ISSUE: Permit to Demolish (complete) and Certificate of Appropriateness for new construction

APPLICANT: 333 North Fairfax Associates, LLC

LOCATION: Old & Historic Alexandria District
333 North Fairfax Street and 300 North Lee Street

Figure 11: Partial elevation and section showing an optional rear projecting bay

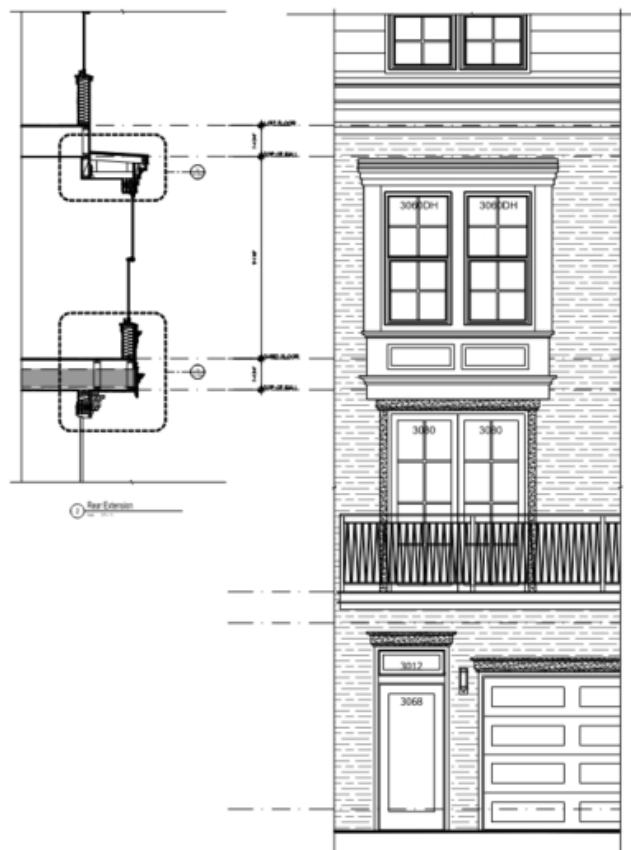
The purchaser of each townhome will have the option to include a projecting rear bay at the second floor at Units B&C. Similar to other portions of the townhomes that are not brick, these bays will be clad in cementitious siding. The design of each bay will be consistent with the design of the townhouse with some including horizontal siding and others with panels similar to the bays at the front of the townhomes (Figure 11). Staff supports the inclusion of these bays where they are included in the final composition. While it is not known at this time exactly which units will include the bays, the variation in their design will add to the variation between the units as requested by the Board during the Concept Review hearings. In fact, if they are not included on all townhouses this will further lead to an organic composition for the rear elevations.
